GRIFFIN ENERGY PTY LTD

**Bluewaters Power Station Phase II
(Bluewaters II)**

Proponent's Response to Submissions

April 2005

Figure 1 - Capacity required to maintain WPC Target Reserve Margin

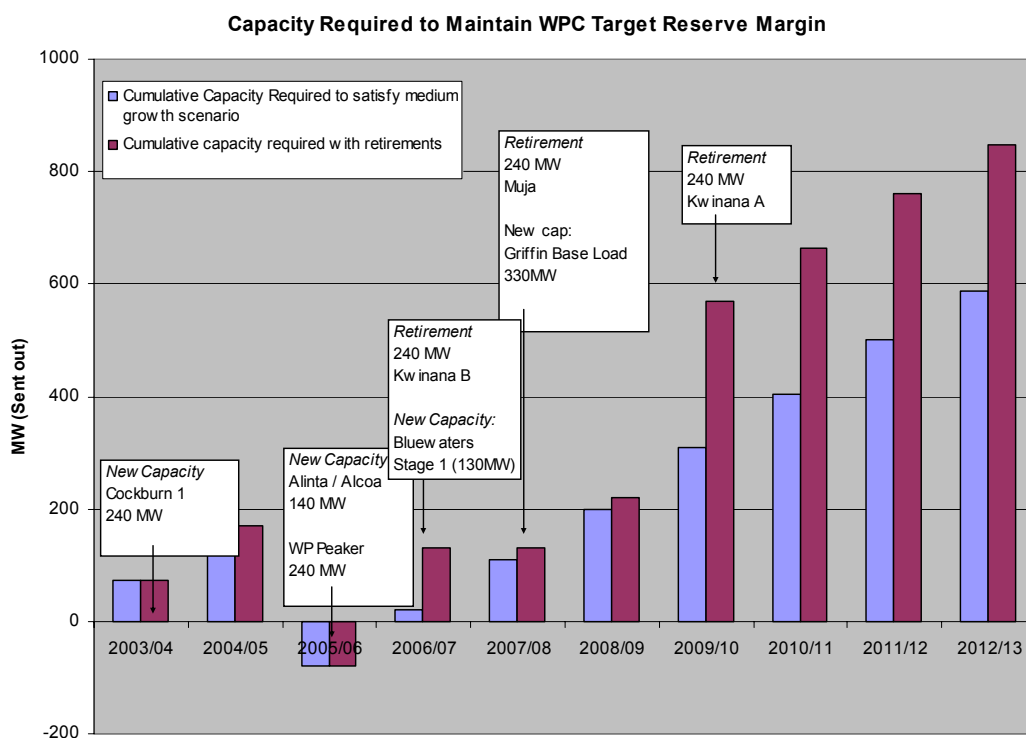
The sub-critical technology proposed for the Bluewaters Power Station is "old technology" and is less efficient than super-critical technology. As Griffin Energy has stated that a 200 MW station is too small to use super-critical technology and Bluewaters II in combination with Bluewaters I is an option for the 300MW Western Power, Power Procurement Process, then it should investigate the option of constructing a larger generator of 400MW that can utilise more efficient technology and justify why 2 X 200MW plants are proposed.

The research referred to suggest that the mix would include 500MW of wind power and 244 MW of bio-electricity. Information available in the public domain suggests that this is not realistic in the near future for WA. The capacity factor for wind power (0.3) would mean that additional spinning reserve would be needed to enable the use of this much wind power in the mix. The current size of the SWIS grid limits the amount of useful wind power to approximately 200MW. Bluewaters II is an option presented to Western Power Corporation for the Power Procurement Process. The power requirement has been previously been justified by Western Power at the initiation of the Power

Procurement Process. The events of February 2004 underlined the importance for the requirement for new electricity generation facilities. The demand is underlined by the realisation that the older less efficient Muja plant is required to be withdrawn from service. The following graph of power demand (Figure 2), using information provided by Western Power, clearly demonstrates the demand for electricity.
